## HISTORIC AND DESIGN REVIEW COMMISSION

HDRC CASE NO: 2015-042

**ADDRESS:** 112 LINDELL PLACE **LEGAL DESCRIPTION:** NCB 6204 BLK 5 LOT 1

**REQUEST:**

SITE PLAN SAN ANTONIO, TEXAS

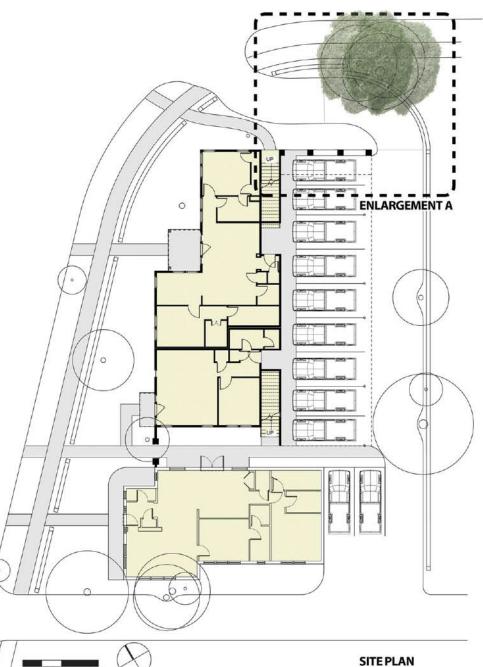
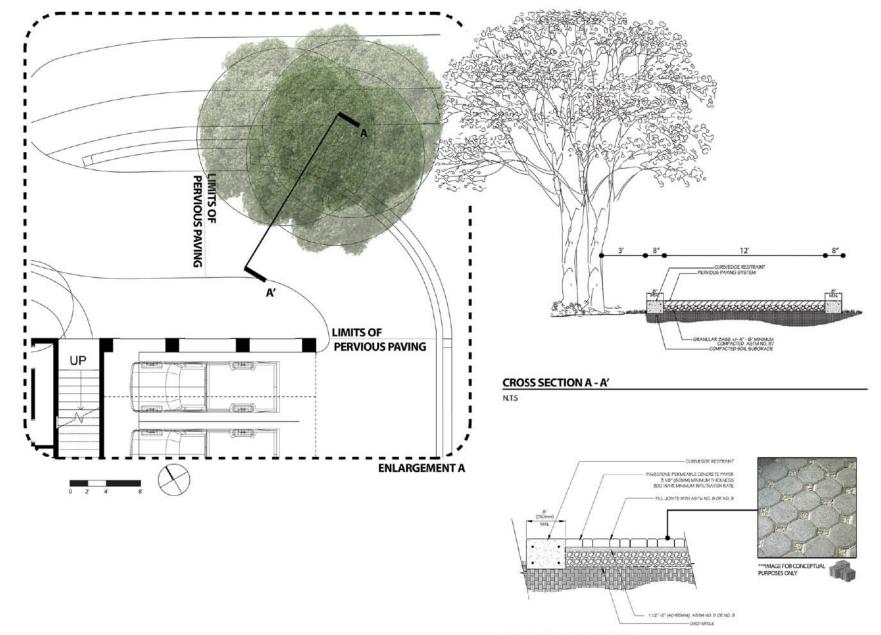
- q. The proposed driveway currently is noted to be 12' 0" wide, which is not consistent with the Guidelines for Site Elements 5.B. The applicant has noted that a providing a driveway with a width that is keeping with the neighborhood precedent is a goal. Staff recommends that the applicant further explore ways to provide a driveway that is consistent with what is historically found in the neighborhood.

- r. The applicant has noted that while the curb cut apron at the street is required by code to be concrete, a series of pervious materials have been proposed for site paving in order to accommodate vehicles. This is consistent with the Guidelines for Site Elements 3.B.i. and ii. in regards to paving materials.

- s. The applicant has proposed on-site parking for eleven (11) vehicles. The Guidelines for Site Elements 7.A. and B. in regards to off-street parking state that parking areas should not be added within the front yard setback, off-street parking should be accessed from alleys or secondary streets rather than from principal streets whenever possible and that off street parking should be screened. The proposed parking is consistent with the Guidelines. The applicant is responsible for complying with the Design Guidelines in regards to permeable materials as well as the proposed parking structure.

- 1. Staff recommends conceptual approval of the rehabilitation of the existing structure noted in item 1 based on findings c through f.
- 2. Staff recommends conceptual approval of the proposed new construction based on findings e through s with the following stipulations:
  - i. That the excavations meet all requirements for archaeology outlined in UDC Article 6, Sections 35-630, 35-634, 35-675 and 35-606.
